Docket Number:	18-IRP-01
Project Title:	Integrated Resource Plan
TN #:	229232
Document Title:	Staff Paper - Review of Vernon Public Utilities 2018 Integrated Resource Plan
Description:	*** THIS DOCUMENT SUPERSEDES TN #228891 ***
Filer:	Harinder Kaur
Organization:	California Energy Commission
Submitter Role:	Commission Staff
Submission Date:	8/6/2019 1:28:13 PM
Docketed Date:	8/6/2019

Review of Vernon Public Utilities 2018 Integrated Resource Plan

July 2019 | CEC-200-2019-006

Figure 1: Vernon and Energy Commission Energy Demand Forecasts 2018–2030 (GWh)

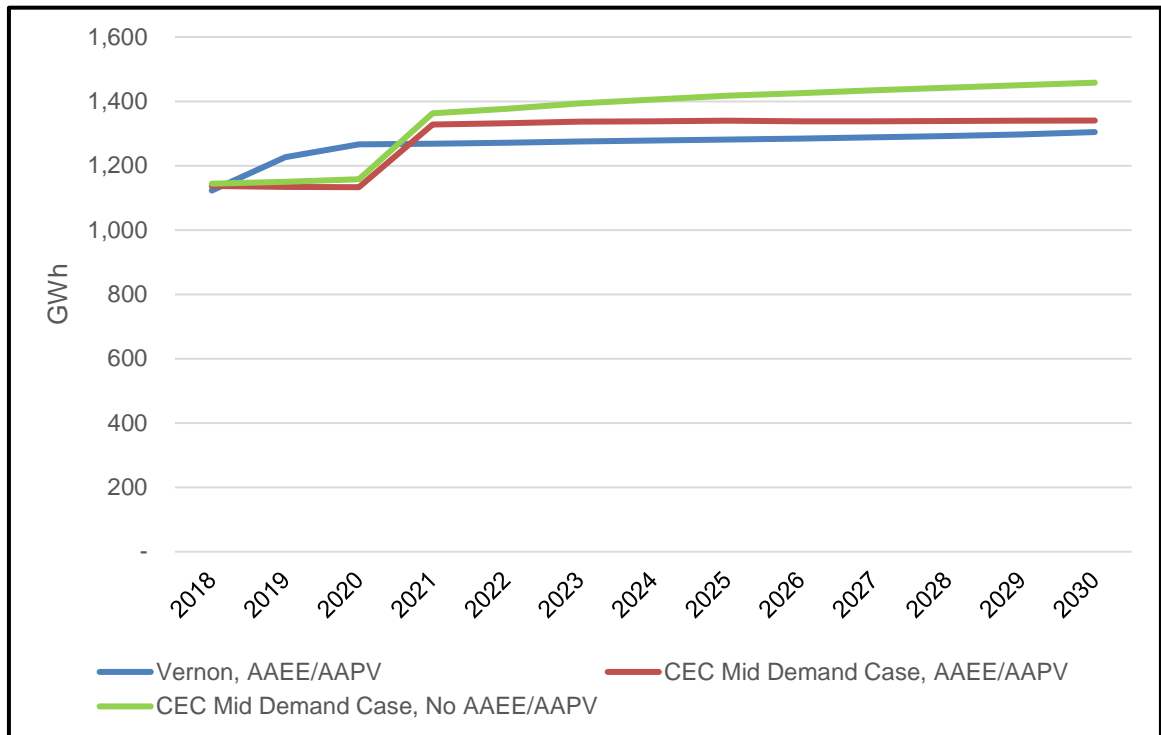
As shown in **Figure 1**, Vernon forecasts retail sales to increase 1.3 percent annually to 1,250 GWh in 2030. Forecasts through 2020 are higher than the Energy Commission’s forecast as Vernon anticipates large customer load additions in this period. By 2021, Vernon’s forecast follows the trend line of the Energy Commission’s demand forecast.

Figure 2: Vernon and Energy Commission Peak Forecasts 2018–2030 (MW)

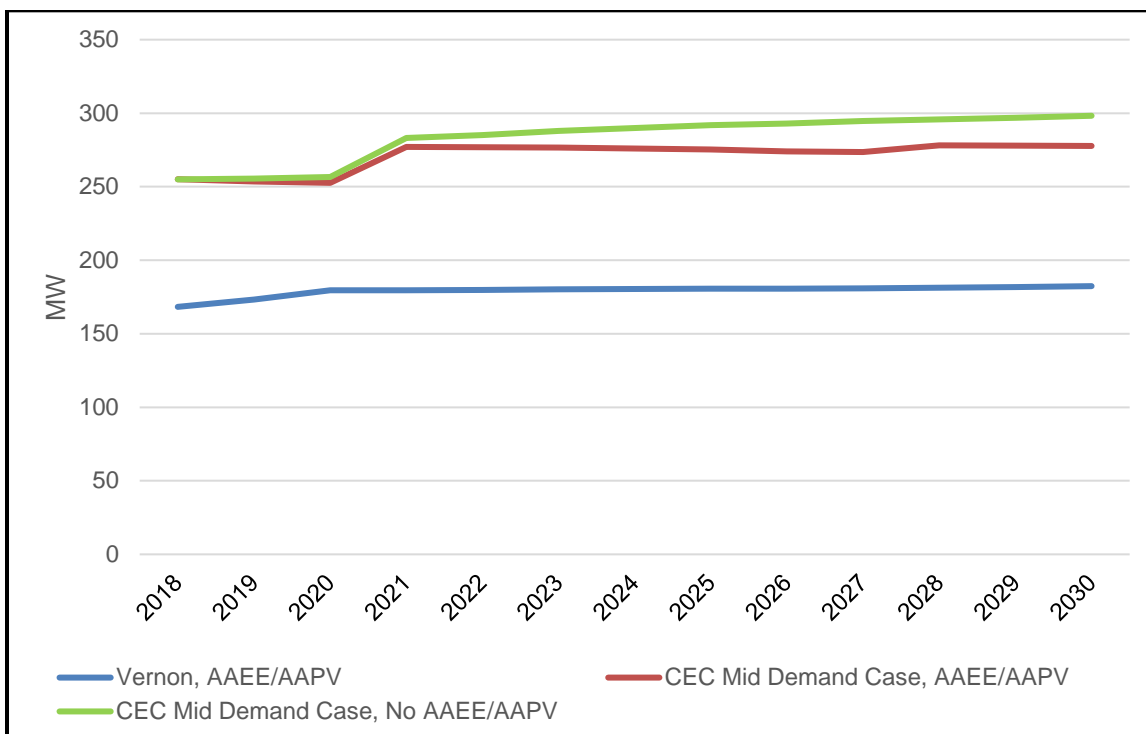
In **Figure 2**, Vernon forecasts a significantly lower peak demand in each year, by about 70 MW, compared to the Energy Commission. Vernon’s forecasts ranges from 199 MW in 2019 to 210 MW in 2030, while the Energy Commission’s forecast ranges from 255 MW in 2019 to 278 MW in 2030 (AAEE/AAPV). Differences between the models specifications, data, and assumptions can make it difficult to compare the long-term demand forecasts developed by Vernon to the Energy Commission’s forecasts.
